ADDENDUM NO. ONE (1)

AIRFIELD PAVEMENT REHABILITATION – PHASE 2

**LYNCHBURG REGIONAL AIRPORT
LYNCHBURG, VIRGINIA**

**AIP PROJECT NO. 3-51-0029-036 (PENDING)
DELTA PROJECT NO. 12121**

AIRFIELD PAVEMENT REHABILITATION-PHASE 2		AIP NO. 3-51-0029-036 (PENDING)	JOB NO. 12121
DEMOLITION PLAN		DRAWN BY: DWS	SHEET 11
LYNCHBURG REGIONAL AIRPORT		DESIGNED BY: TJS	OF 69
SCALE: 1" = 30'	DATE: MAY 2013

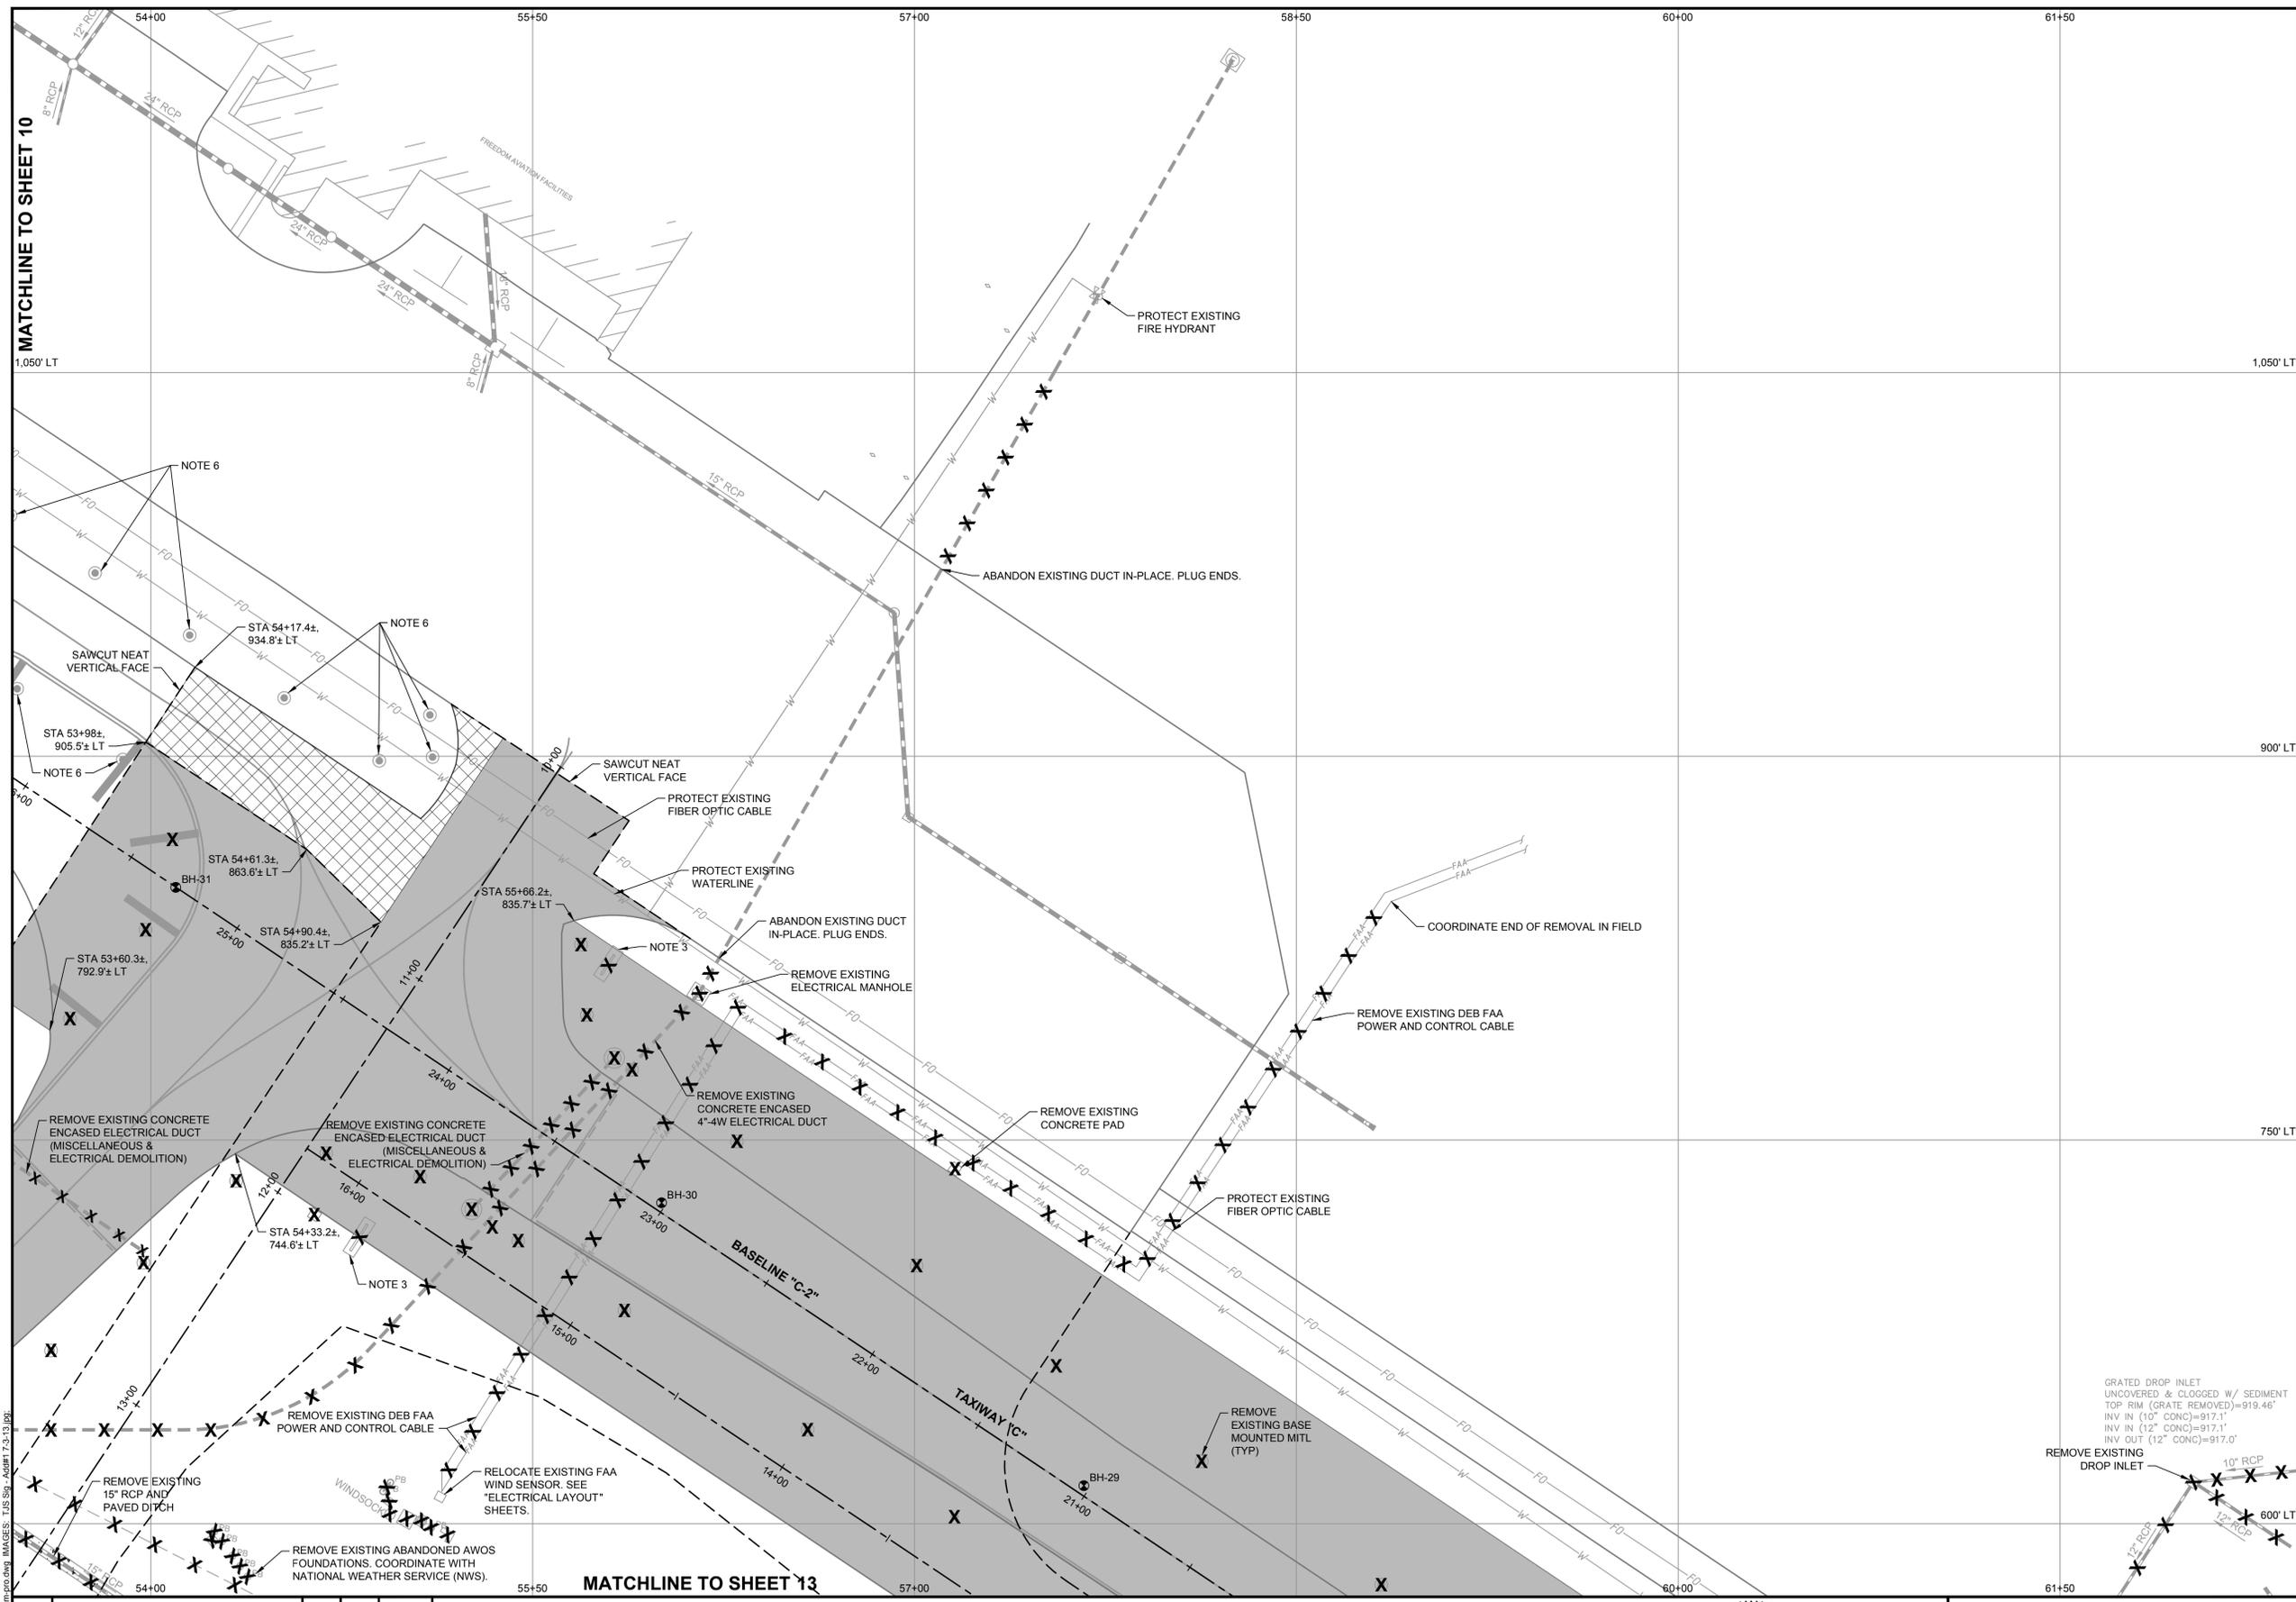
- 13. REPLACE** Sheet 11 of 69 with the attached Sheet 11 of 69 of Addendum No. One (1).

AIRFIELD PAVEMENT REHABILITATION-PHASE 2		AIP NO. 3-51-0029-036 (PENDING)	JOB NO. 12121
GRADING & DRAINAGE		DRAWN BY: DWS	SHEET 22
LYNCHBURG REGIONAL AIRPORT		DESIGNED BY: TJS	OF 69
SCALE: 1" = 30'	DATE: MAY 2013

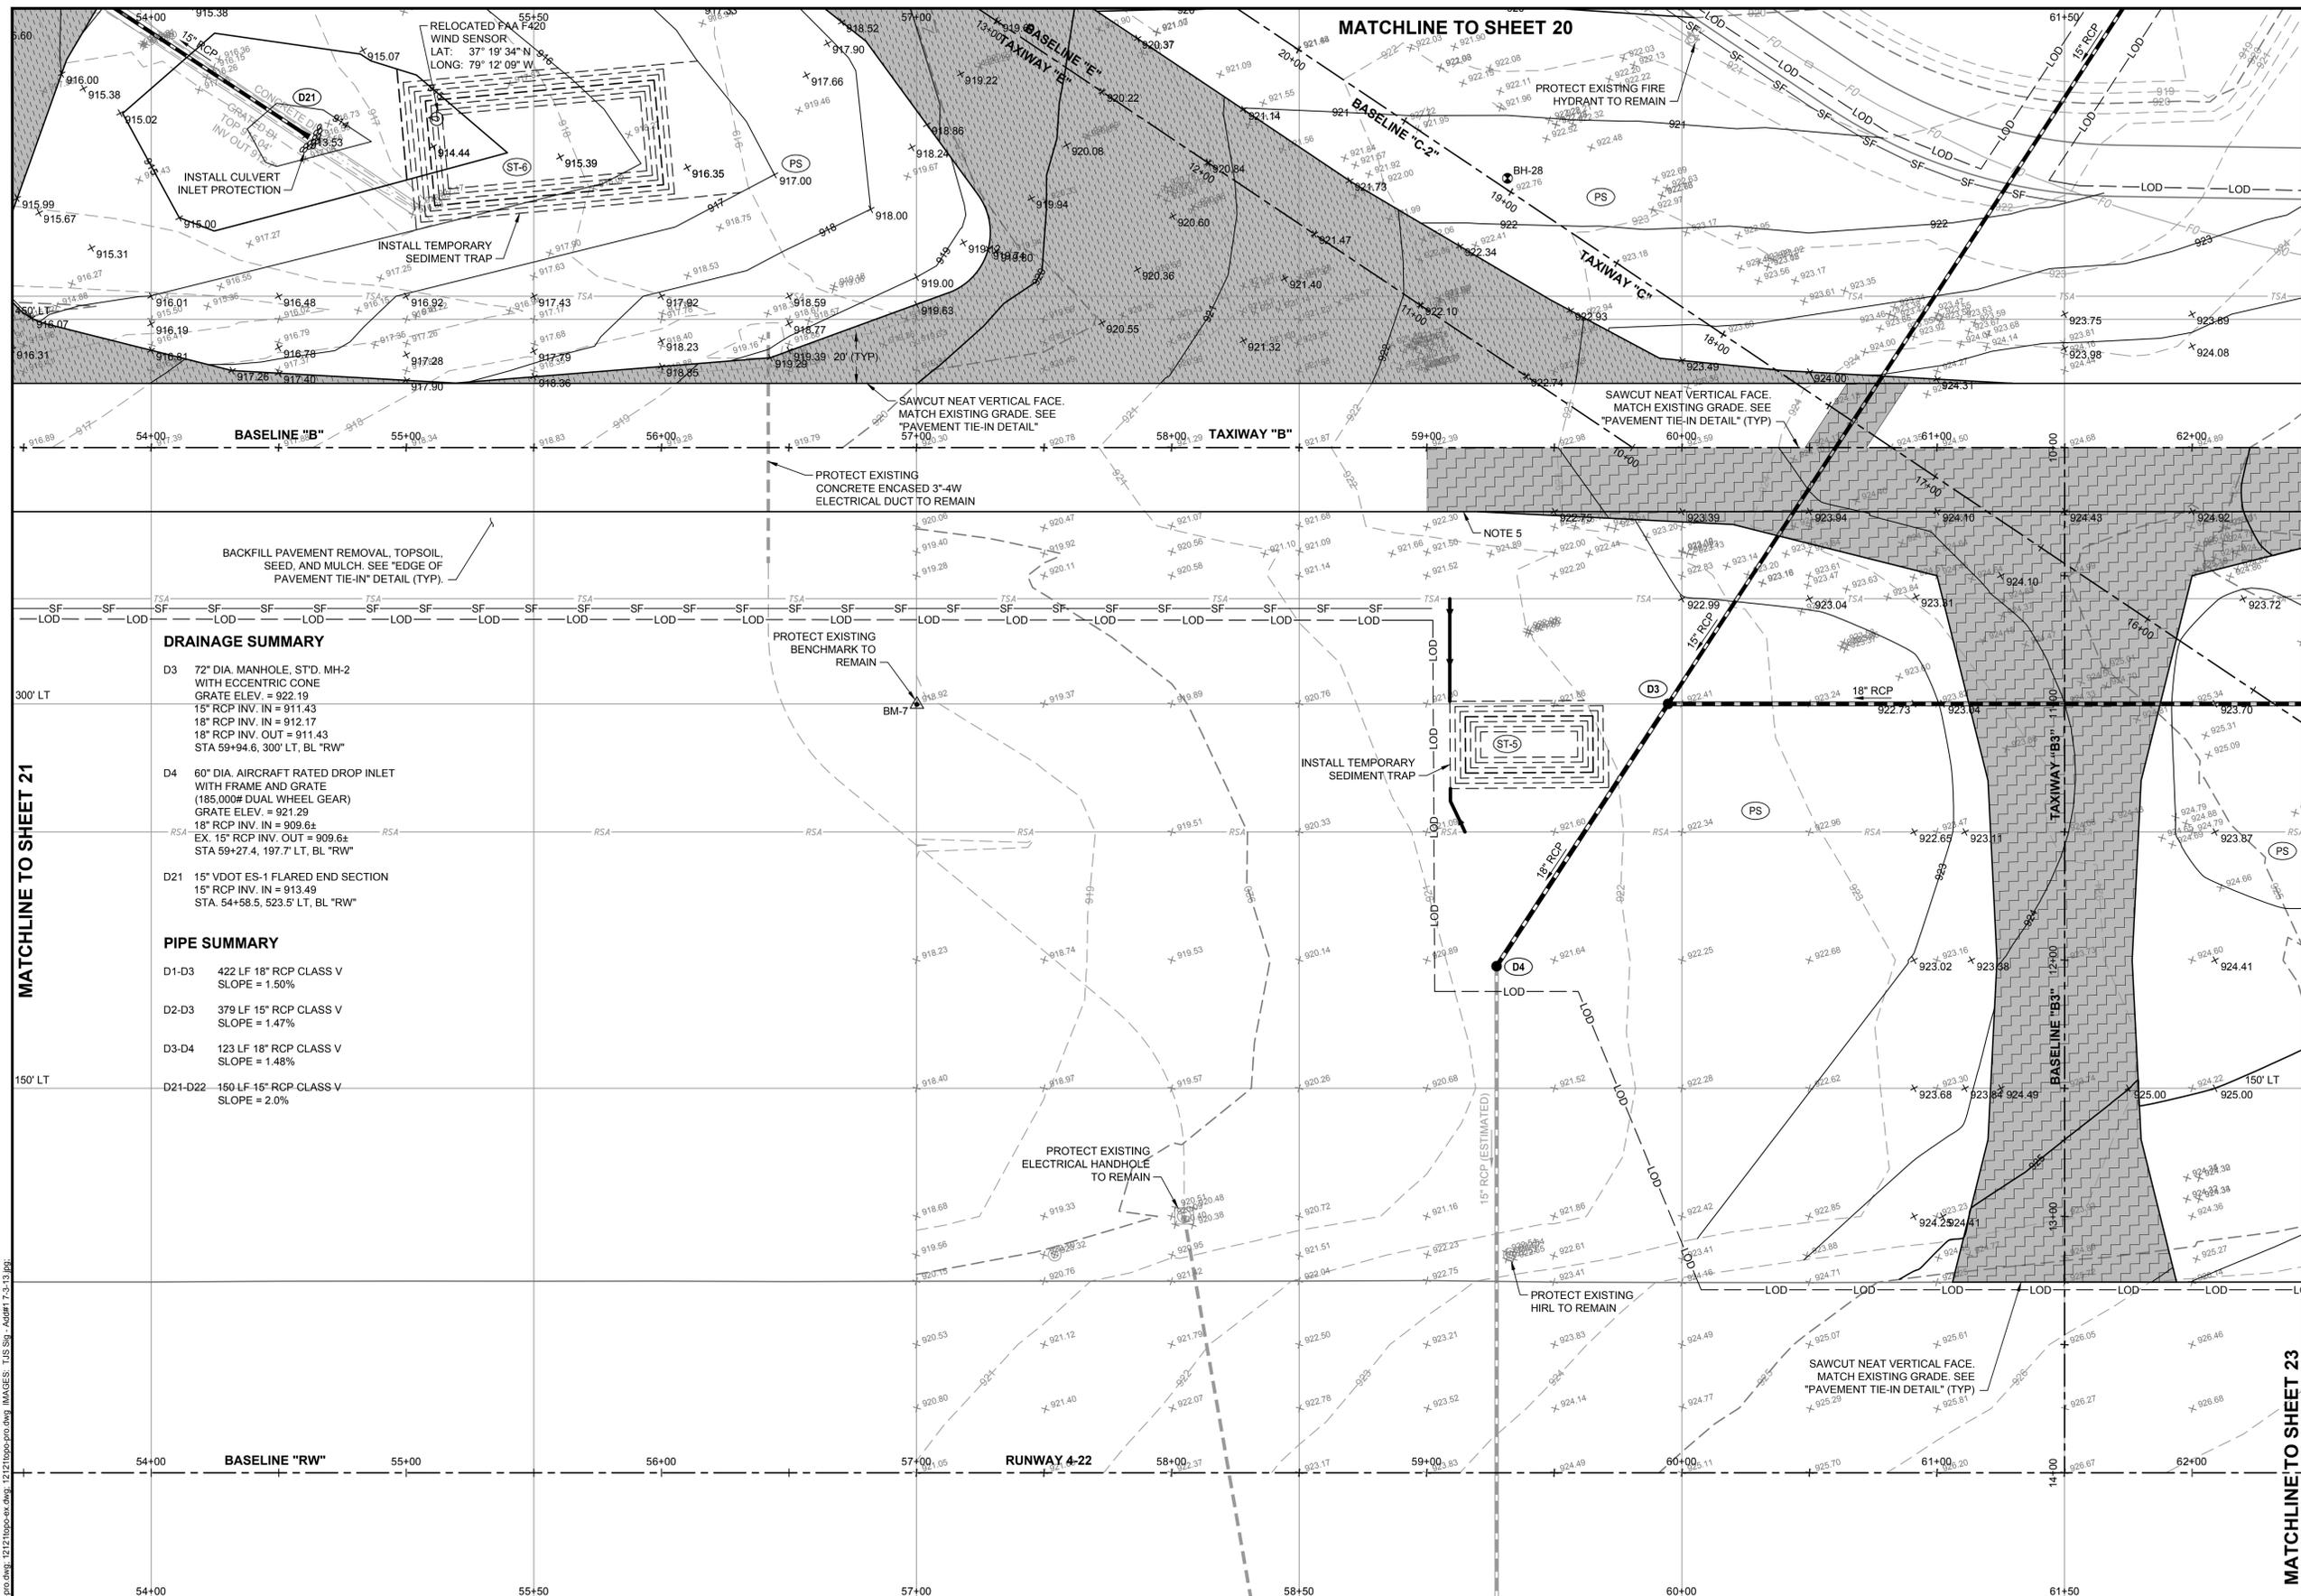
- 16. REPLACE** Sheet 22 of 69 with the attached Sheet 22 of 69 of Addendum No. One (1).

AIRFIELD PAVEMENT REHABILITATION-PHASE 2		AIP NO. 3-51-0029-036 (PENDING)	JOB NO. 12121
GRADING & DRAINAGE		DRAWN BY: DWS	SHEET 23
LYNCHBURG REGIONAL AIRPORT		DESIGNED BY: TJS	OF 69
SCALE: 1" = 30'	DATE: MAY 2013

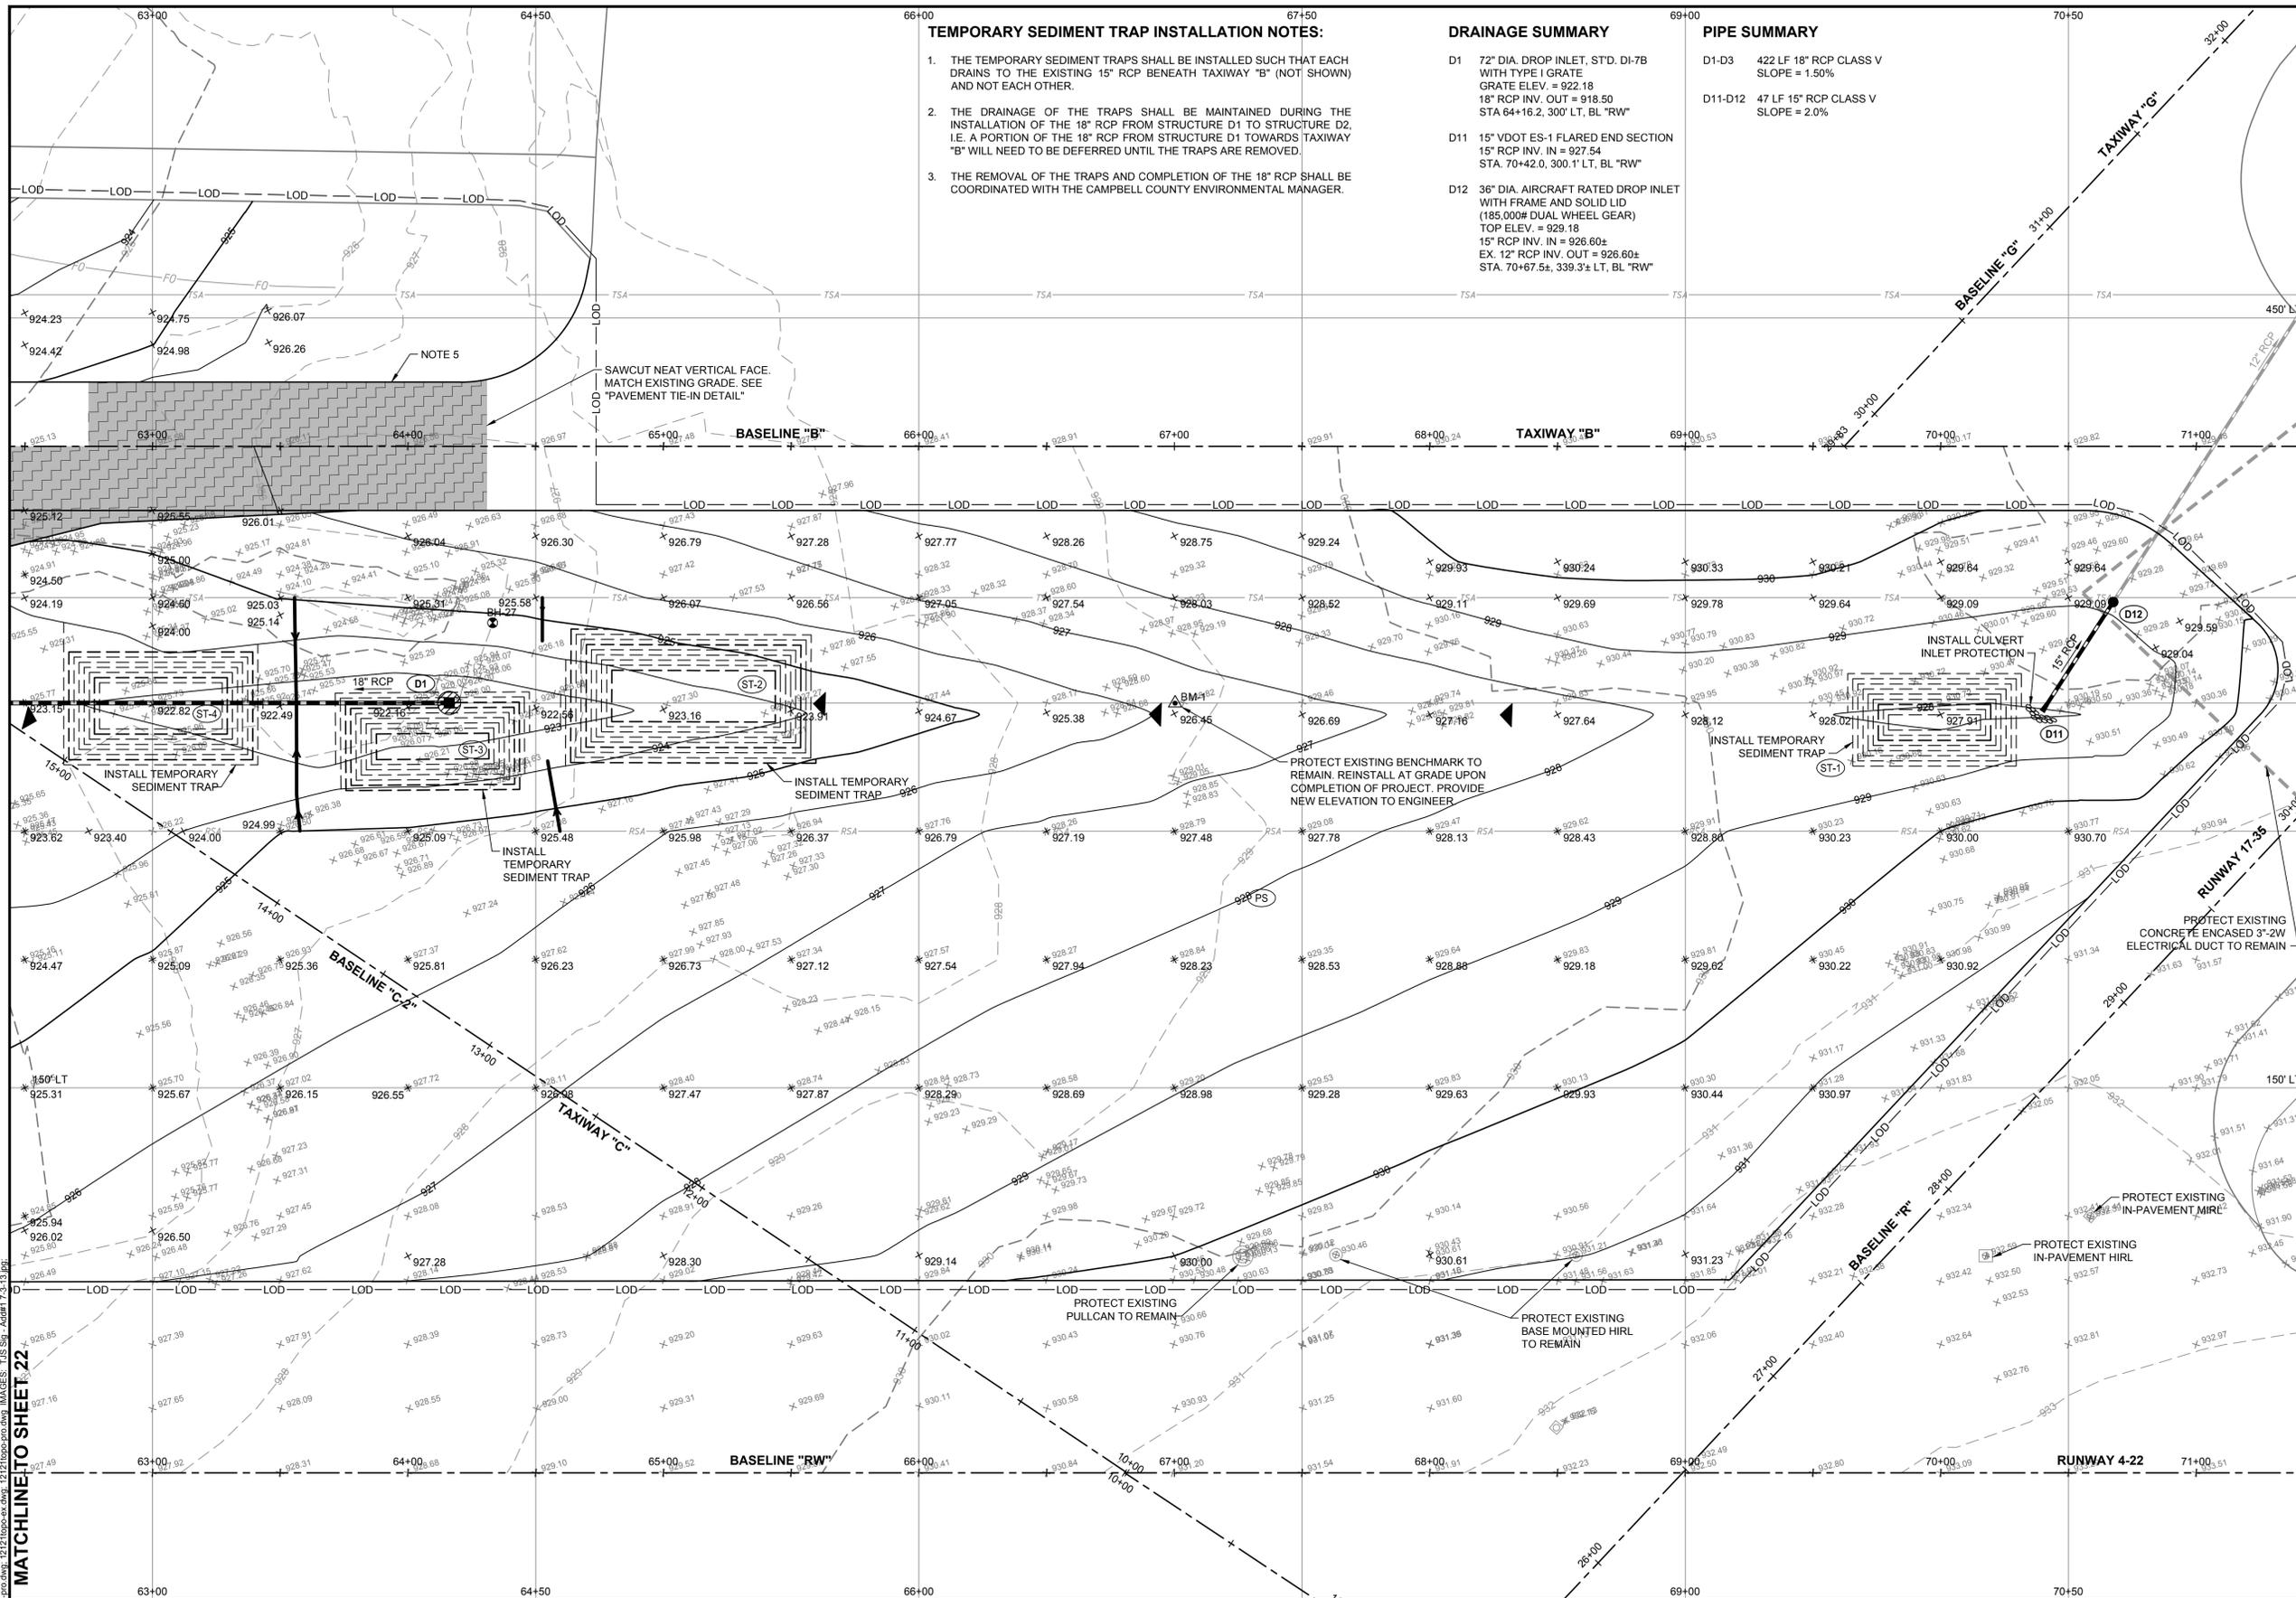
- 17. REPLACE** Sheet 23 of 69 with the attached Sheet 23 of 69 of Addendum No. One (1).
